Moser Pass At Denali Final Development Plan

REQUEST: The applicant is seeking approval of final development plan and final plat by demonstrating compliance with all conditions of approval that are specifically required. This submittal specifically addresses the incompleteness items included in the October 24, 2023, incompleteness letter.

II. INCOMPLETENESS LETTER ITEMS

**MOSER PASS AT DENALI
 SHERWOOD, OREGON**
PARTIAL SITE PLAN - ELECTRICAL

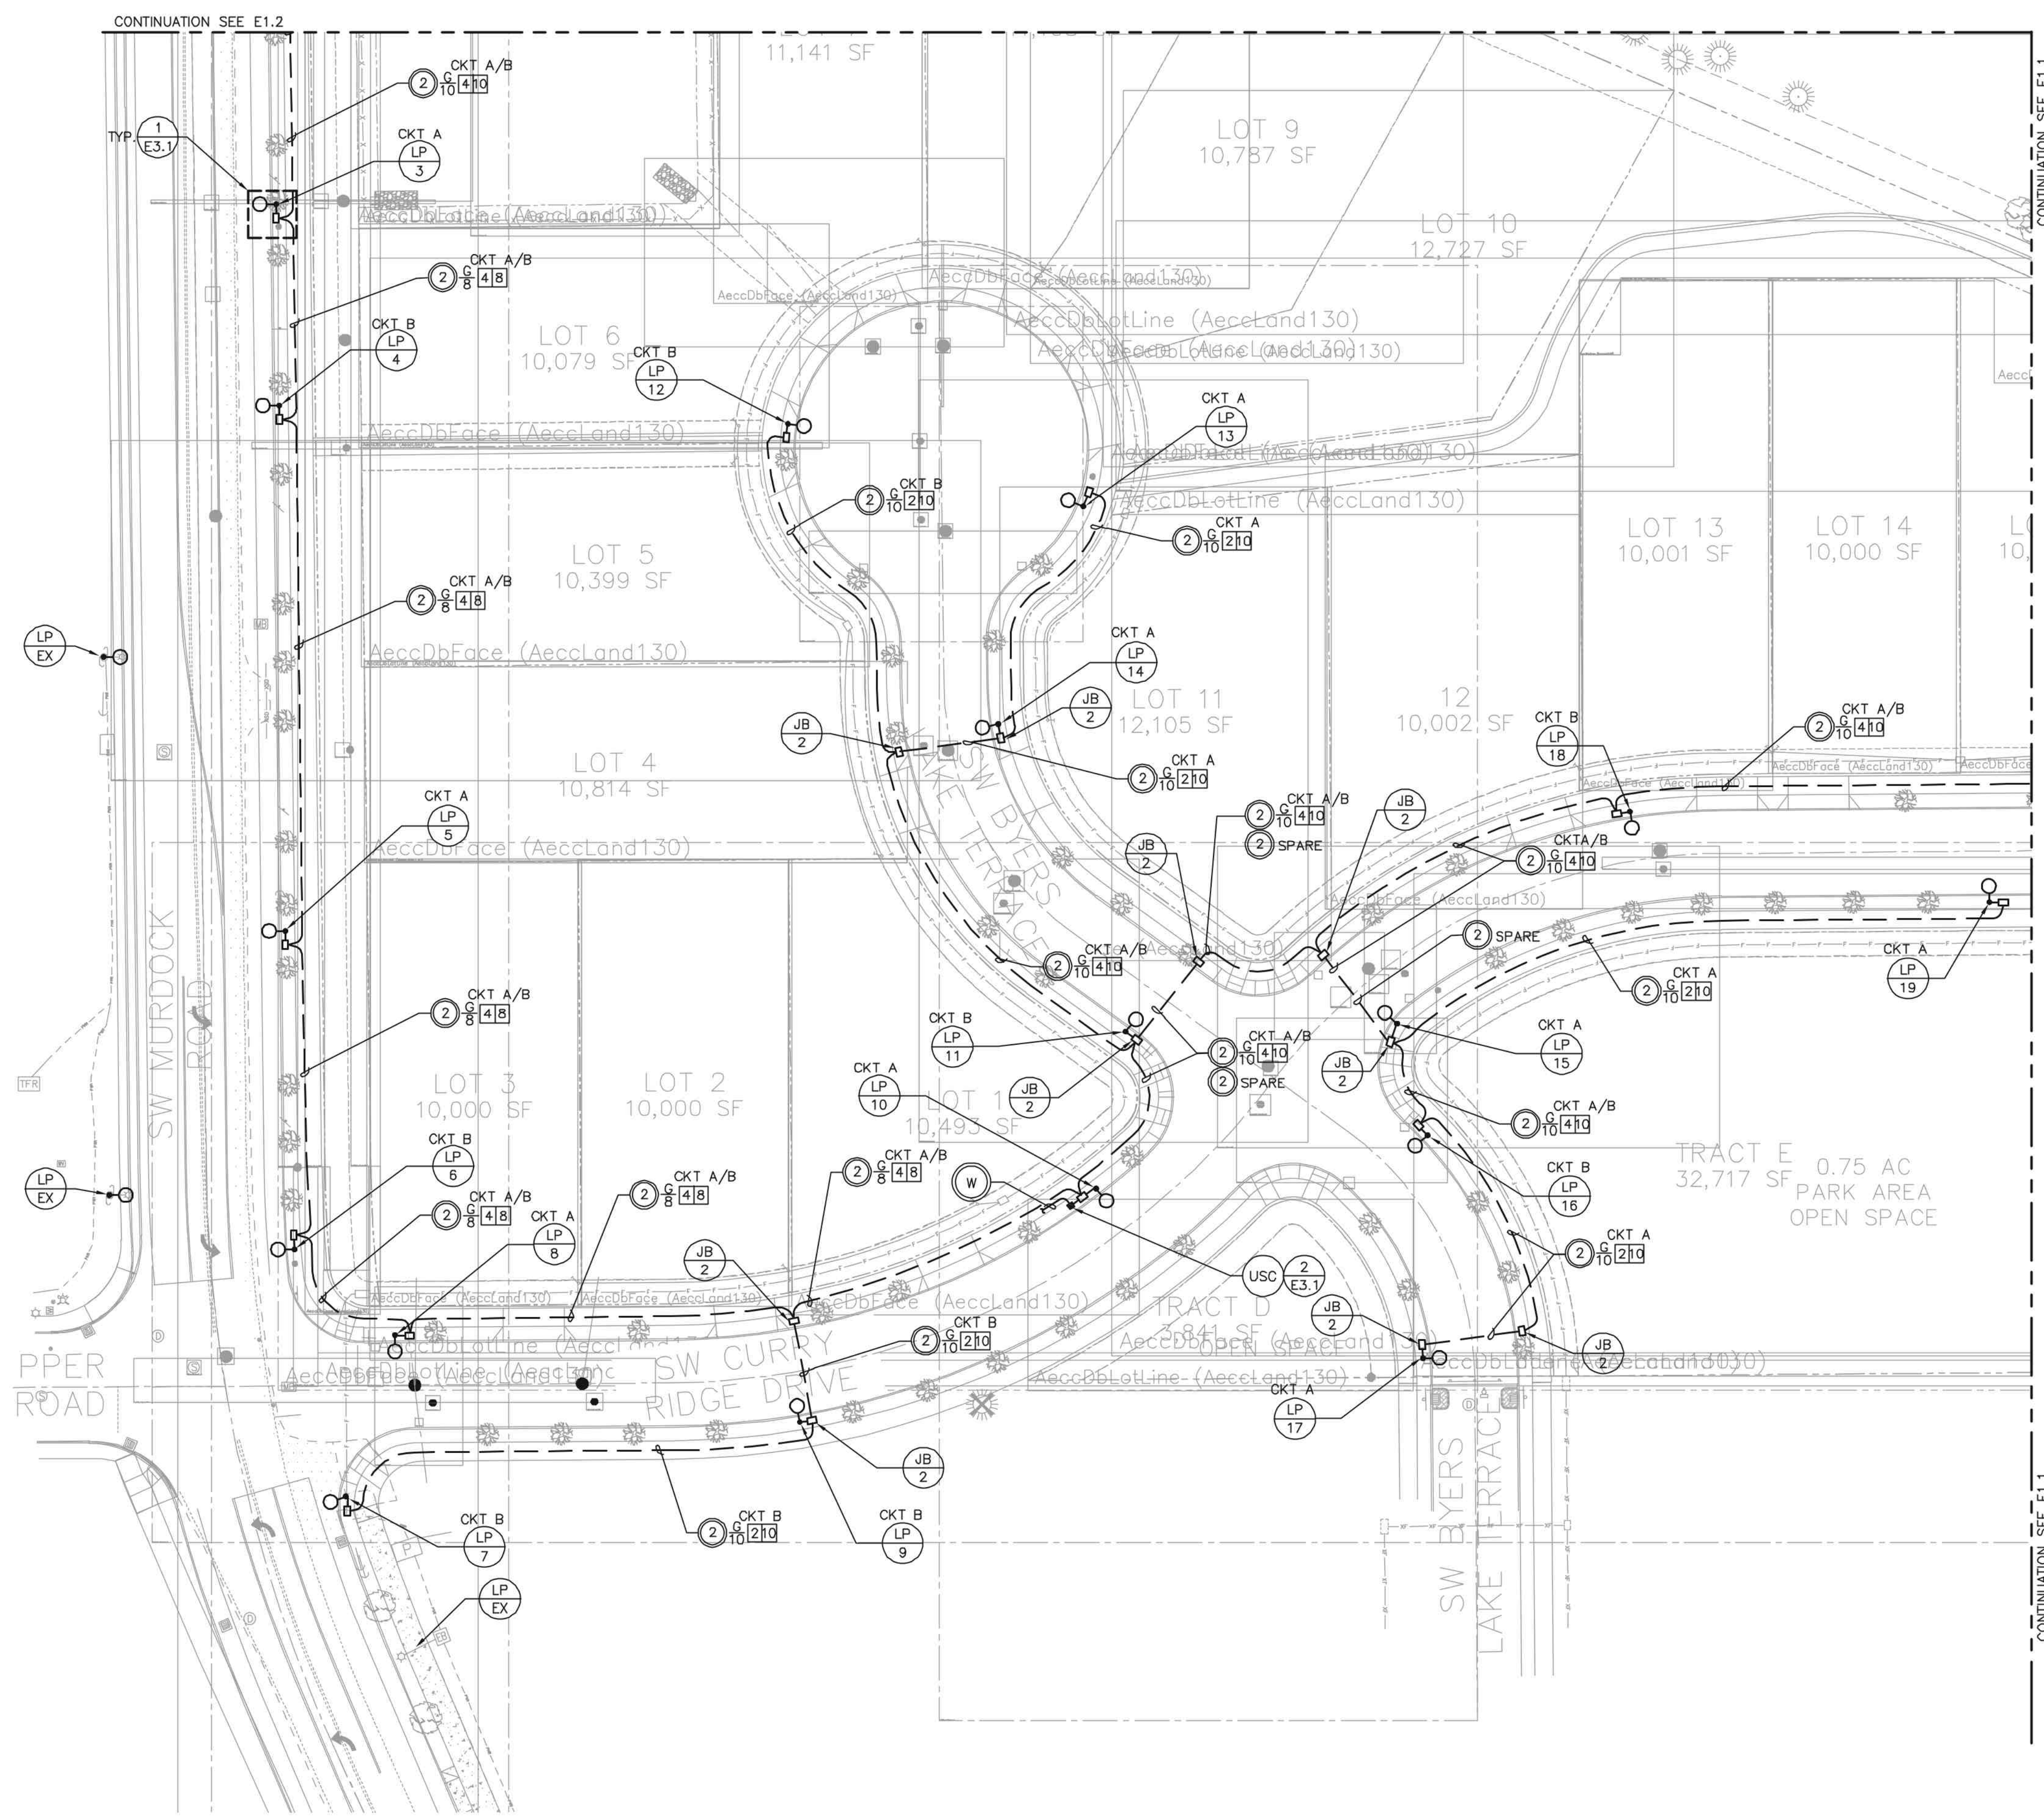
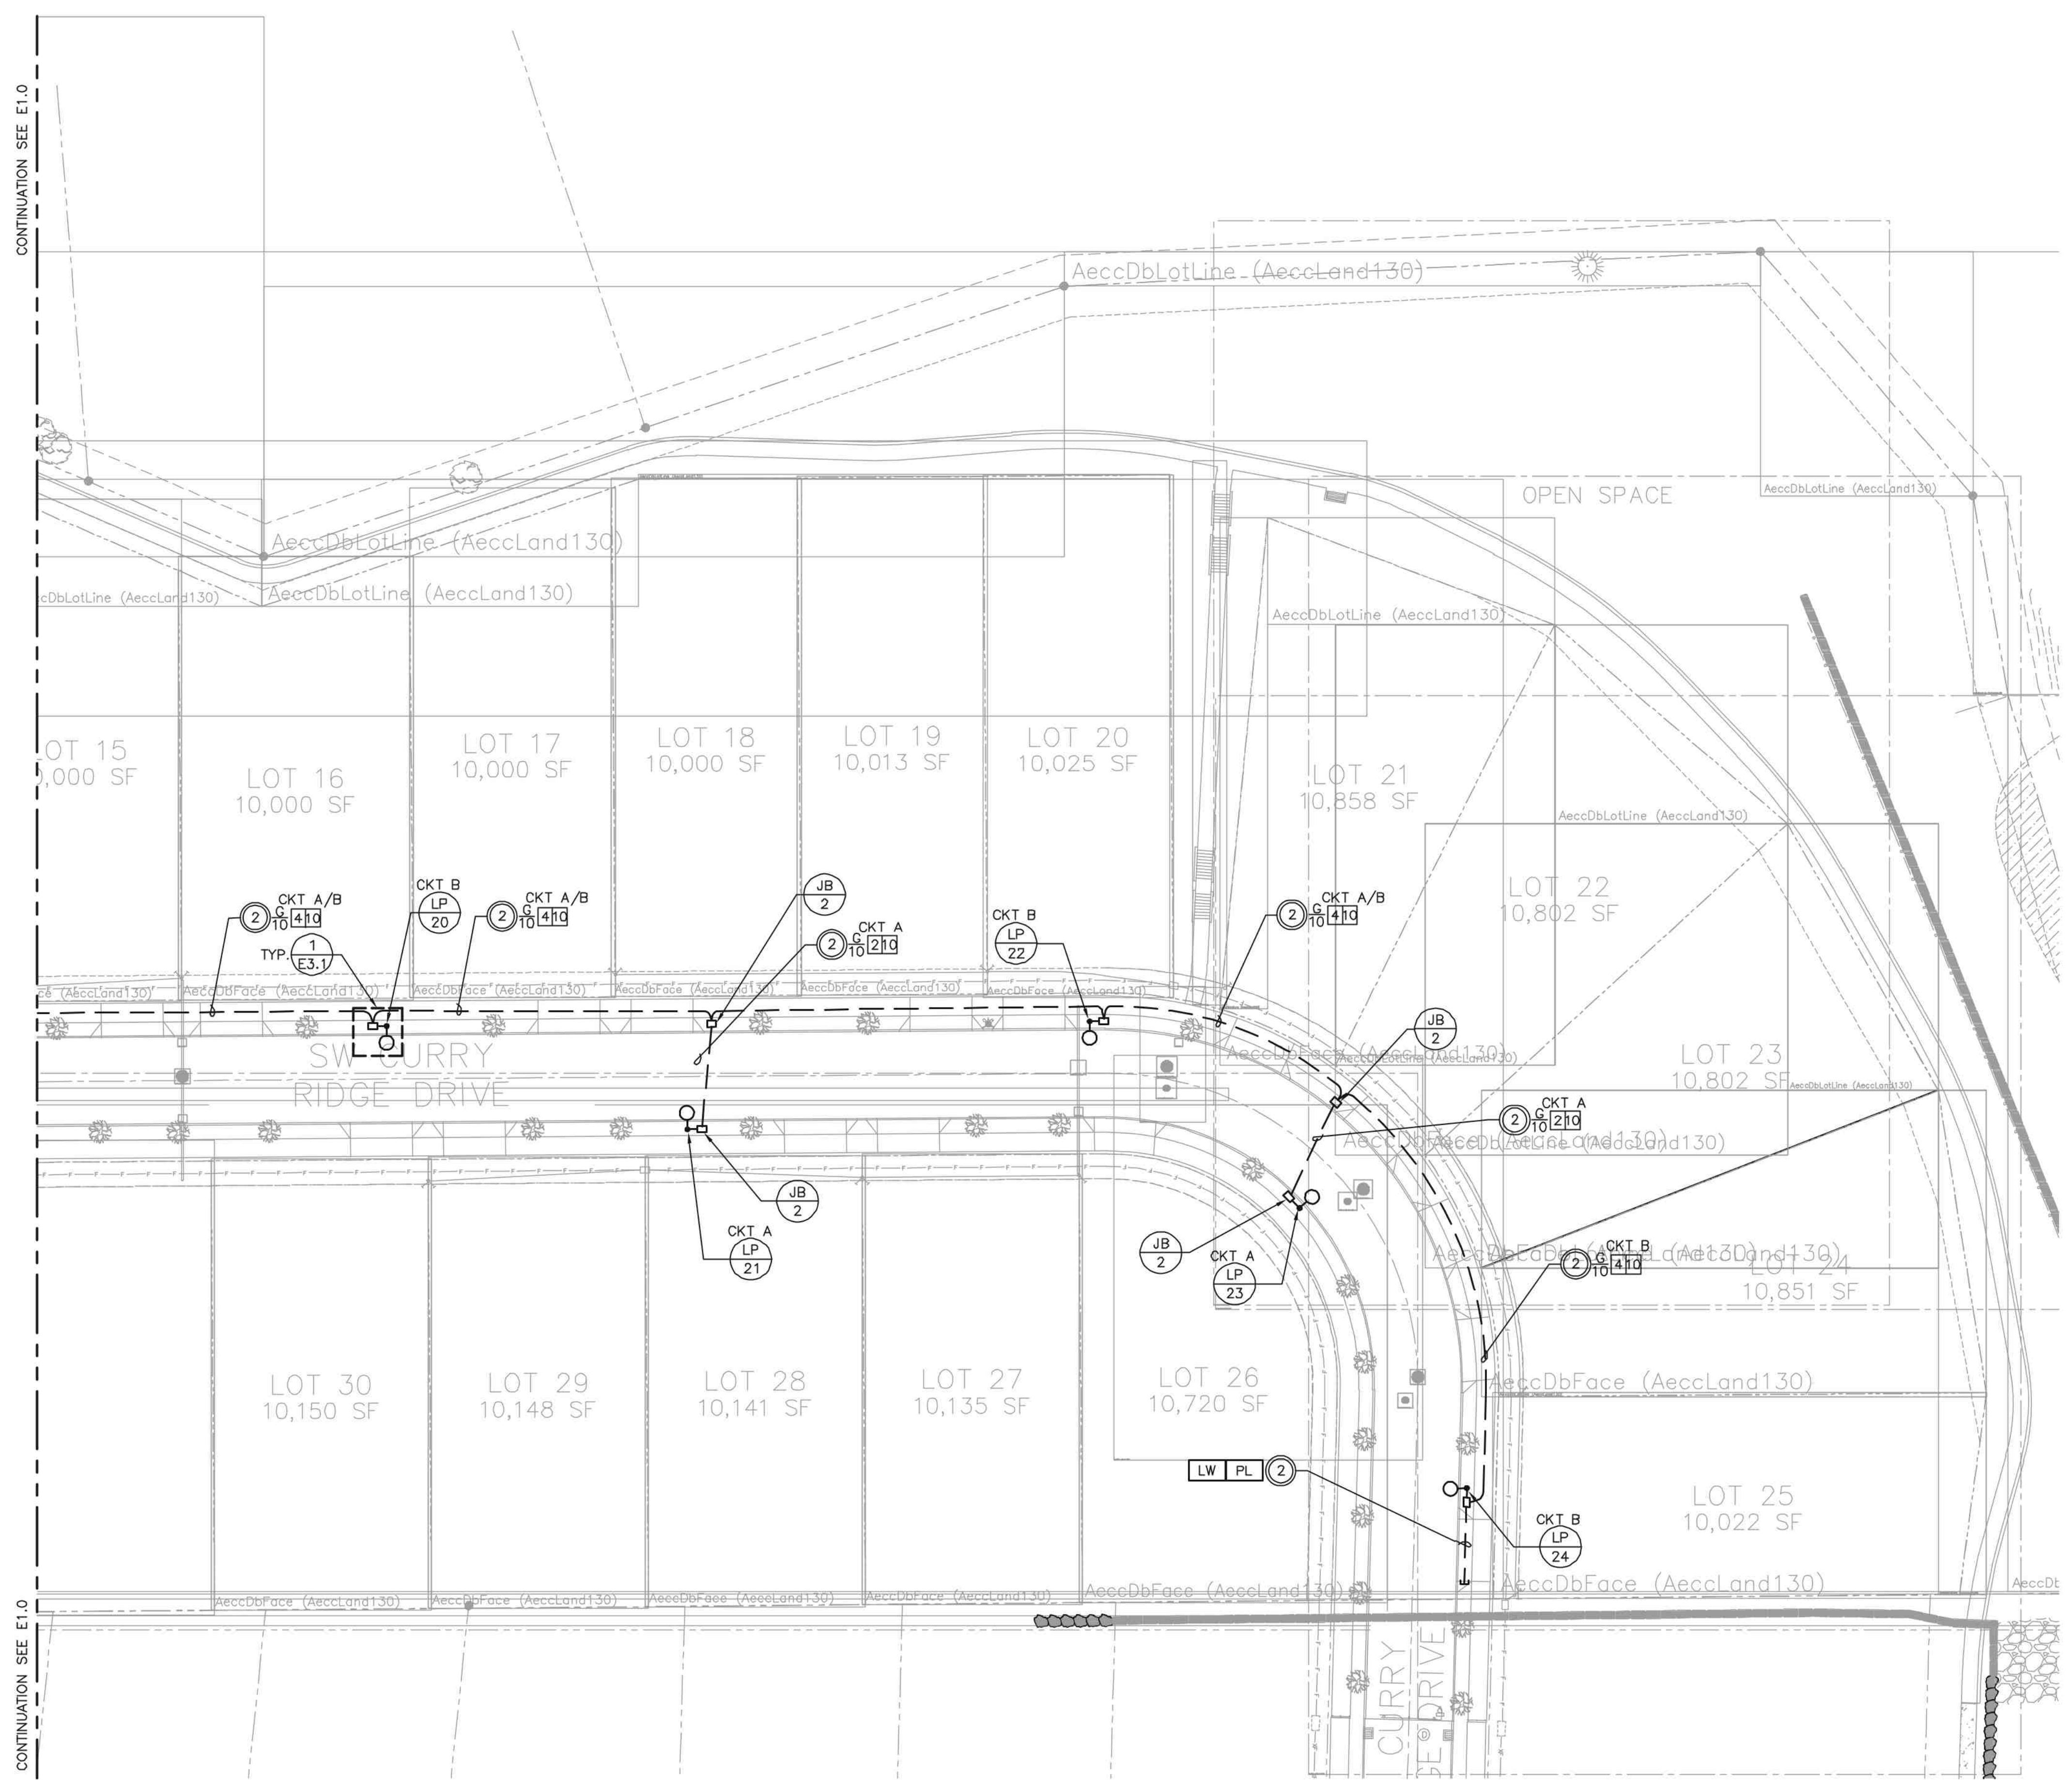
Submit a lighting plan.

Applicant Response: The lighting shown on the park plan exhibit (Exhibit D) is consistent with the submitted lighting plan to address the comment above. The applicant has removed the bocce ball court and horseshoe pits from the plan and has replaced those facilities with a basketball court to meet the desire of the City. The gazebo is shown to have an 'interior' area of 600 sf, includes a picnic table and lighting (lighting also reflected in the submitted lighting plan). The restroom detail has been added for reference and remaining Public Works conditions are ongoing.
